# Access Compliance Report

## Public Rights-of-Way

### (Curb Ramps)

Intersection ID: N/A	Main Street: MILLENNIUM_AV	Cross Street: POTOMAC_RIVER_PY	Location: SE
ADA ID: A3E829156DAD	Ramp Type: Directional1	Initial Pass/Fail: Fail	Overall Compliance: No
Severity Score: 13.75			
Codes/Mitigation Info/Possible Solution		Field Measurements/Component Compliance

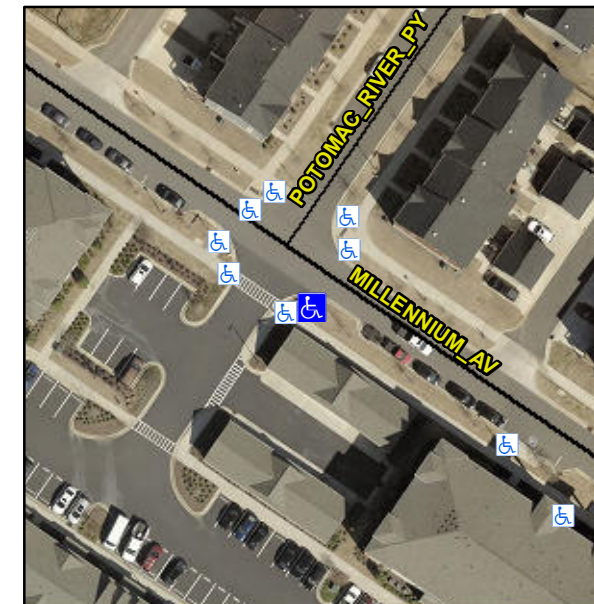
**R304.2.2, R304.5.3**

**Remove & Replace Entire Ramp.**
